## Memorandum

To: Sandy Hsiao on behalf of Auckland Council

Re: Further Information Response – 223 Kohimarama Road and 7 John Rymer Place, Kohimarama

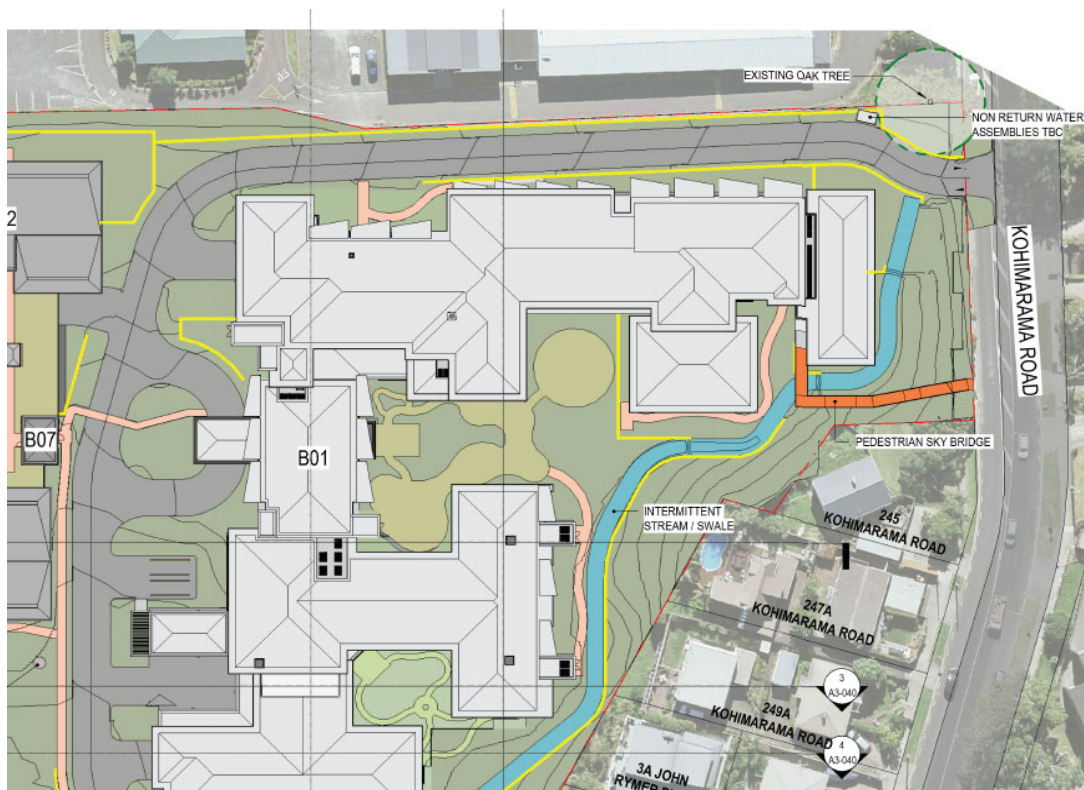
18. Please confirm that the existing drainage on/from Kohimarama Road (and shown on drawing 004 revD) will be incorporated into the proposed drainage shown on drawing 006 revB.

Beca's response to this request for further information is attached as **Appendix H** to this memorandum. A sketch illustrating the conveyance of the Kohimarama Road stormwater connection is also included in **Appendix C** to this memorandum.

Figure 1: HIRB Length Building B04

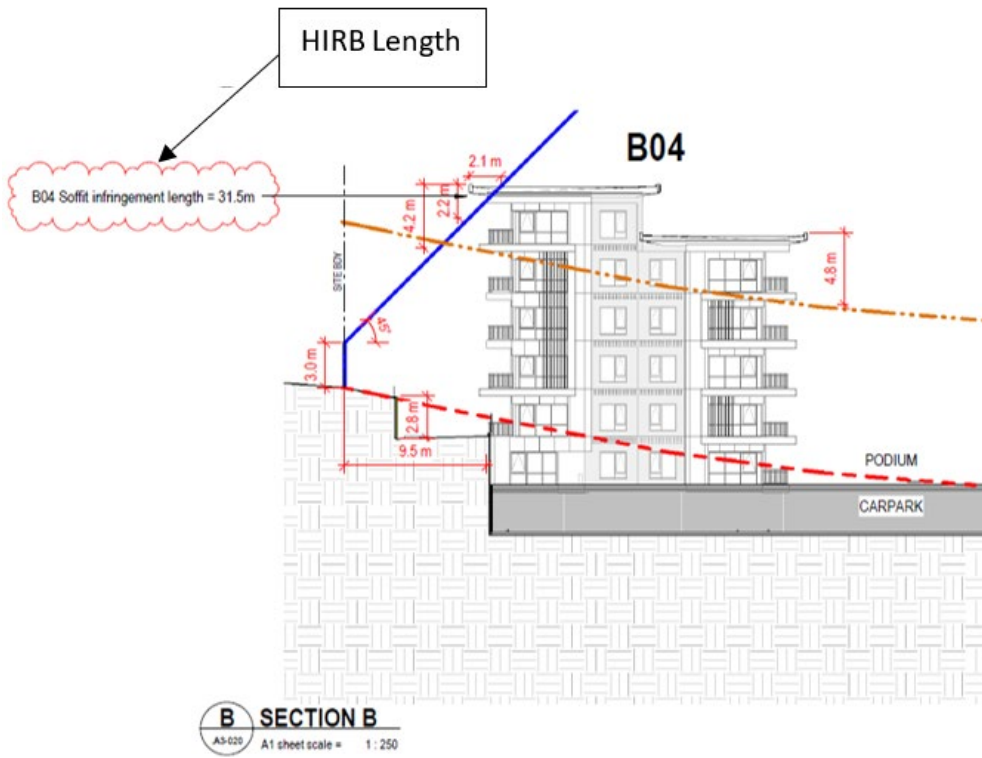
1. *Please advise the specific plan reference which shows the lengths as I couldn't clearly identify this. The purpose of this request was just so that the infringements can be properly identified and listed within the reasons for consent.*

The lengths of the HIRB infringements for Buildings B02 and B04 are shown in clouds on Drawing 044-RCT-S01-A3-020 provided in Appendix B - Resource Consent Drawings, previously provided as part of Ryman's response to further information on 17 April 2020. However, they are also illustrated on Figures 1 and 2 below for ease of reference.

**Figure 1. Conceptual drawing showing mussel spat rope in the weir low flow channel.**

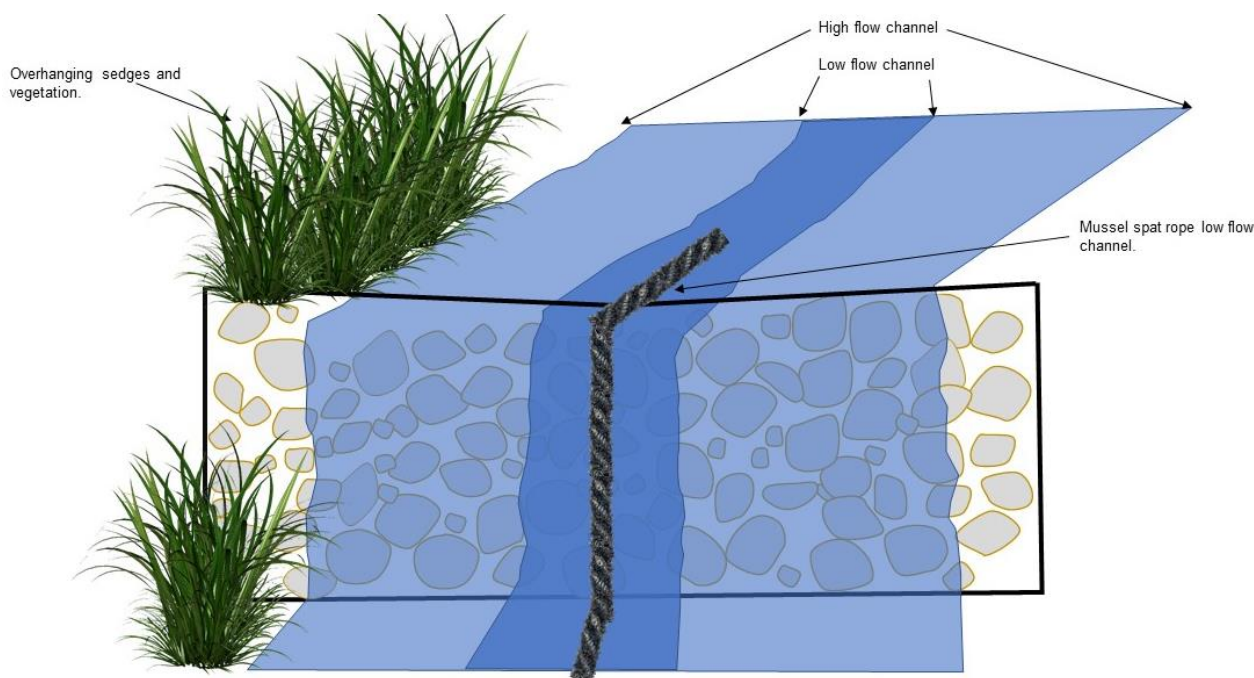
70. *The stream design plans lack sufficient design detail to support that fact that the stream will become a hard bottom with woody debris elements. Please provide further details around the stream design and habitat details.*

The lowermost weir (1H:4V) will have a lower gradient and a low flow channel formed into it that will maintain a continuous stream of water during times when the stream is flowing. The lower weir will allow good passage for climbing native fish species (e.g., banded kōkopu and eels) into a 99 m section of the new stream. The uppermost 72 m headwater section of the stream will have a notably steeper gradient and three vertical concrete weirs are proposed along this section. Banded kōkopu and eels are excellent climbers and might be able to negotiate the three upper vertical weirs. To improve fish passage it is proposed to install and maintain mussel spat rope in the low flow section of each of the upper three weirs (refer to Figure 1). This will ensure that any fish that reach the base of these weirs will be able to access the short section of stream habitat upstream. All weirs will be constructed to have pools immediately above and below them to

provide resting areas for fish. It is recommended that a condition be included in the consent that requires the installation and maintenance of mussel spat rope at the upper three weirs.

**1 SECTION D**  
A1 sheet scale = 1 : 100

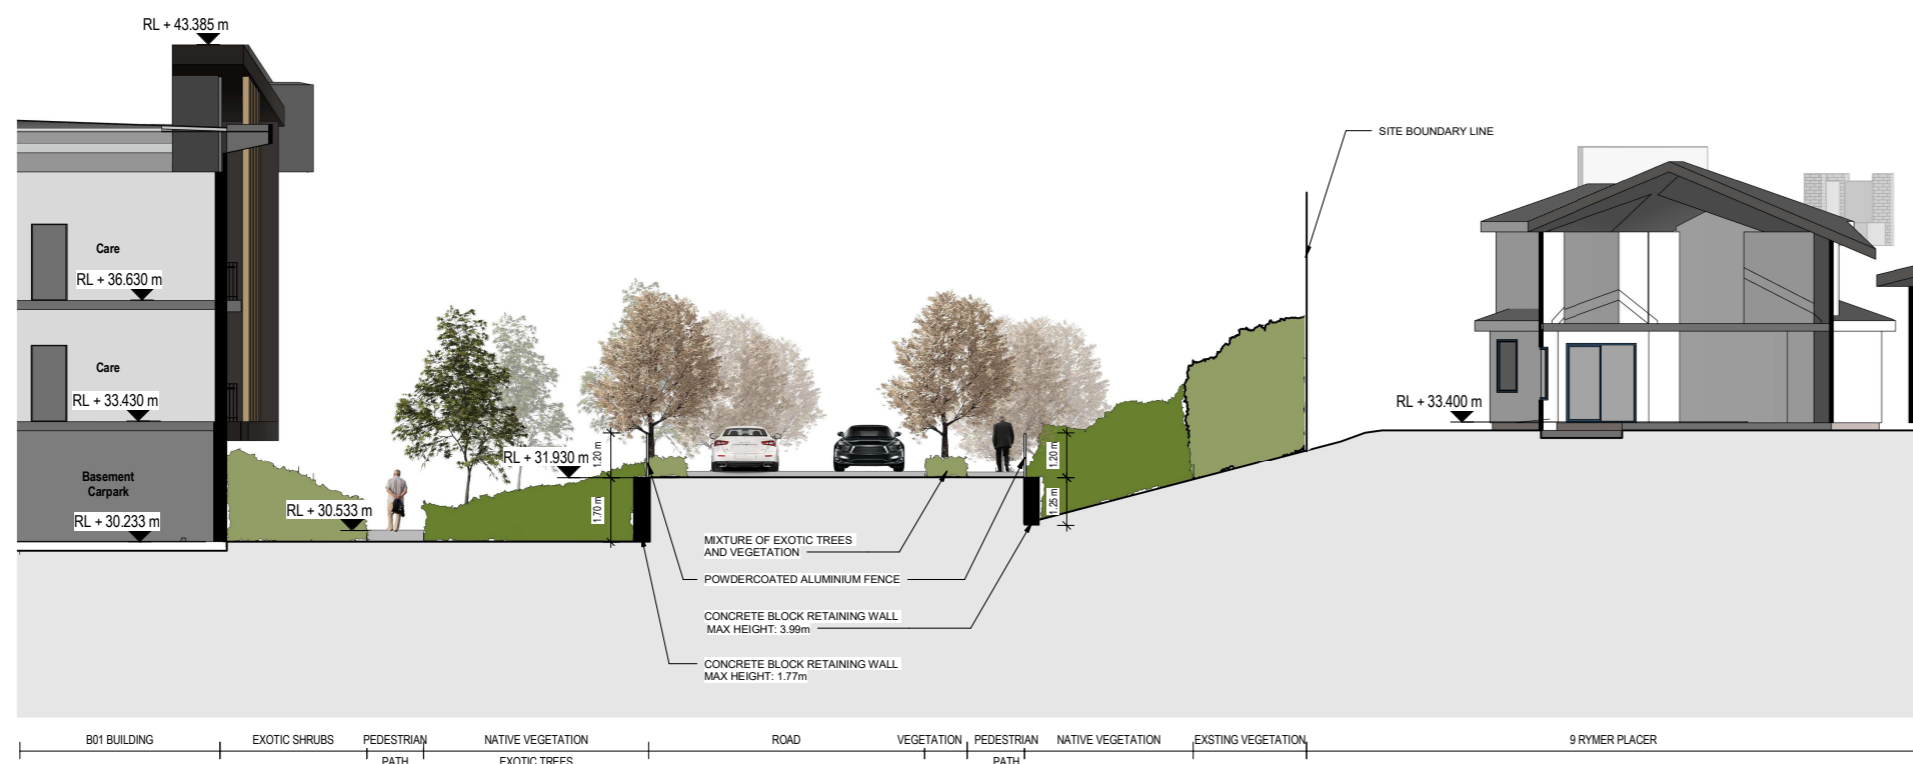
*The left is the GA section from the s92 response dated 17.04.2020. The detail section below (right) seem incorrect. Can the applicant please clarify this. Again, this section should clearly show levels, retaining, fencing, planting and adjoining footpath.*

The above sections have been updated showing levels, retaining, fencing, planting and adjoining footpath and is provided in **Appendix A** to this memorandum.

Schematic Sketch of Proposed Overland Flow Paths

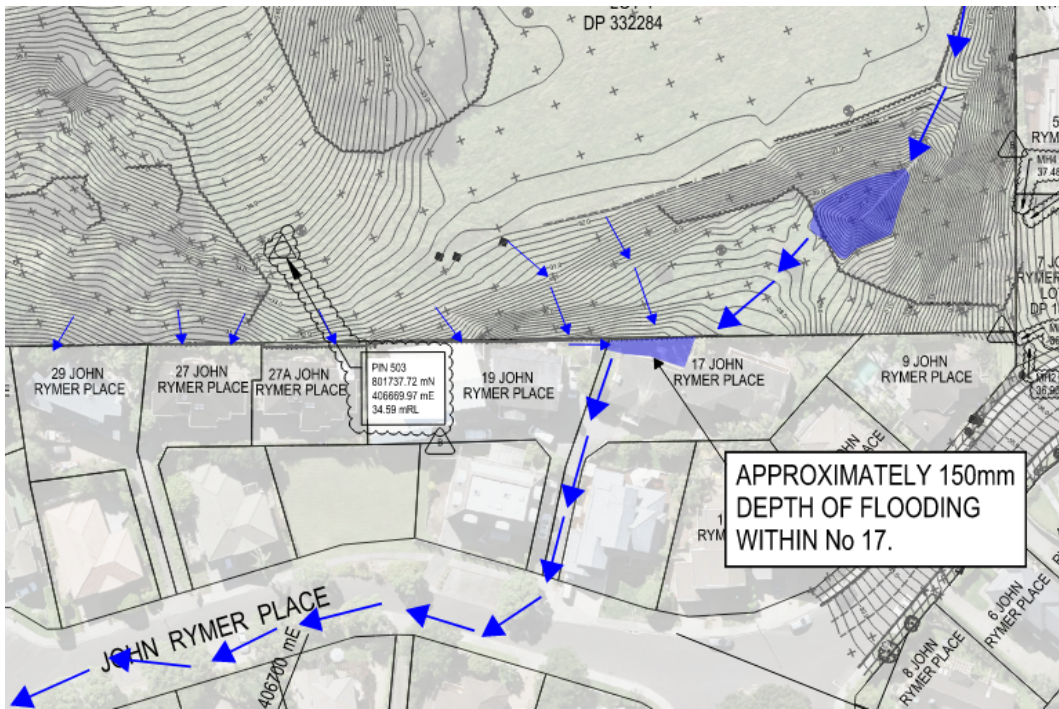
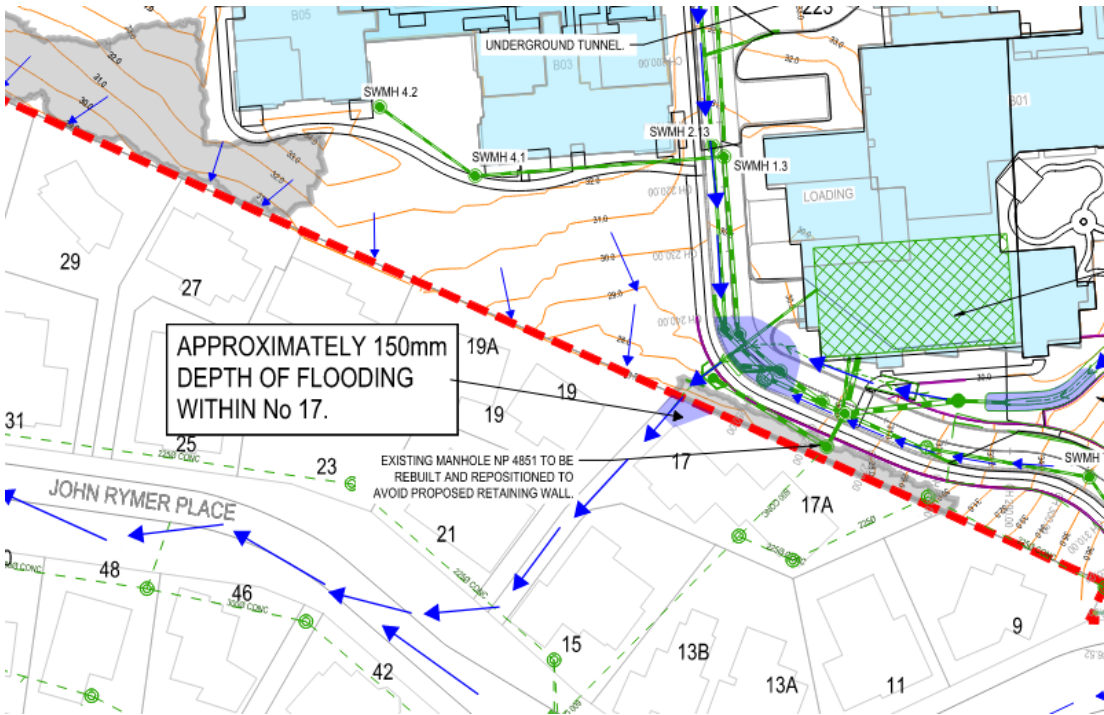
13. *Please provide an updated E36.9(2) flood risk assessment as required by including the following considerations:*
  - o *Flood hazard management plan for the site*
  - o *Discuss the Freeboard proposed and hazard risk around these , referencing the cross sections provided*
  - o *Potential future modifications to the stream design and safety in design workshop at detailed design stage to potentially increase the freeboard particularly at Section 2 and 3 e.g. widening/deepening channel etc taking into account ecological aspects of the proposed re-aligned stream and the retaining wall design at X section2.*
  - o *Use of the top of wall (29.6 m RL) to prevent flows from leaving the site, protecting downstream properties. Note peak 100yr ARI Water level in the OLFP is RL 29.62m at the two scruffy domes (Connor to confirm this arrangement).*

The proposed overland flow path exit point from the site and into the No 17 John Rymer Place property will be altered and improved in the post-development condition as outlined in Section 6.1.7.
